Access Compliance Report

Public Rights-of-Way

(Curb Ramps)

Intersection ID: 10025024	Main Street: DONNELLSON_COMMON_CT	Cross Street: N/A	Location:	N/A
ADA ID: B01F61534757	Ramp Type: Perp	Initial Pass/Fail: Fail	Overall Compliance: No	Severity Score: 17.5
Codes/Mitigation Info/Possible Solution			Field Measurements/Component Compliance

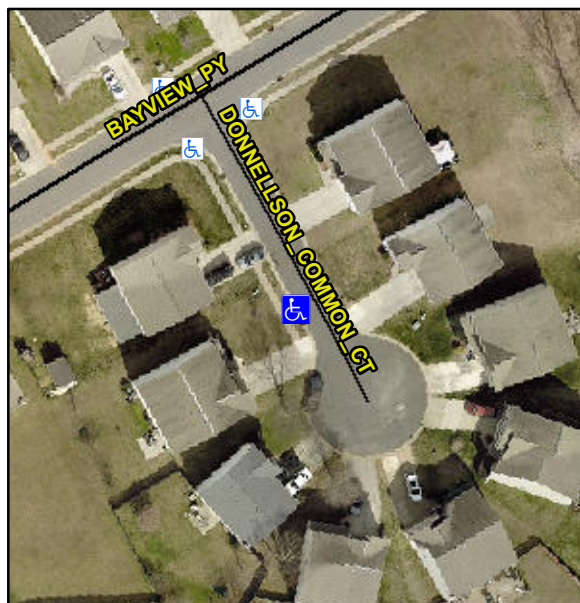
Not Found, R304.5.1

Compliance	Description	Data	Compliance	Description	Data
N/A	Ramp Length (in)	48.0	Yes	Ramp Slope (%)	8.3
No	Ramp Width (in)	32.0	Yes	Ramp XSlope (%)	0.4
N/A	Flare Type LT	N/A	N/A	Flare Type RT	N/A
N/A	Flare Slope LT (%)	N/A	N/A	Flare Slope RT (%)	N/A
N/A	Flare Traversable LT?	N/A	N/A	Flare Traversable RT?	N/A
N/A	Landing Length (in)	N/A	N/A	DWS Provided?	N/A
N/A	Landing Width (in)	N/A	N/A	DWS Contrast?	N/A
N/A	Landing Slope (%)	N/A	N/A	DWS Length (in)	N/A
N/A	Landing X Slope (%)	N/A	N/A	DWS Full Width?	N/A
N/A	Landing Curb? (Y/N)	N/A	N/A	DWS Offset (in)	N/A
N/A	Shared Landing?	N/A			
N/A	Gutter Ponding?	N/A	N/A	Gutter Slope (%)	N/A
N/A	Gutter Lip Ht (in)	N/A	N/A	Gutter X Slope (%)	N/A
N/A	Painted X Walk1?	No	N/A	Painted X Walk2?	N/A
	X Walk 1 Direction	To E		X Walk 2 Direction	N/A
N/A	X Walk 1 Width (in)	N/A	N/A	X Walk 2 Width (in)	N/A
	X Walk 1 Slope (%)	1.3		X Walk 2 Slope (%)	N/A
	X Walk 1 X Slope (%)	3.1		X Walk 2 X Slope (%)	N/A

Remove & Replace Entire Ramp.
